Bulletin No. 2002-18

Carburetor Fuel Inlet Clamp - 25 Four Stroke

2002 & 2003 25 HP Four Stroke

a - Carburetor Inlet Fuel Line Clamp

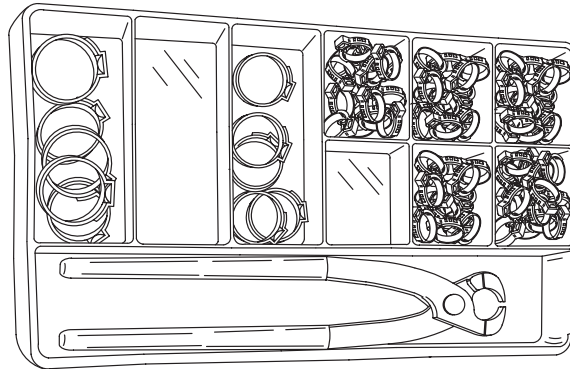
When servicing the carburetor on the models listed in this bulletin, install a new 12.8 mm Oetiker stainless steel clamp 54-888441 to the inlet fuel line connection. The new clamp greatly improves the fuel line connection to the carburetor. The metal fuel clamp replaces the nylon sta-strap previously used.

The only way to ensure proper installation of the Oetiker clamp is to use the proper clamp tool 91-803146T that is included in the Oetiker Hose Clamp Kit 91-803146A2. The new 12.8 mm clamp will be included in the clamp kit in the near future.
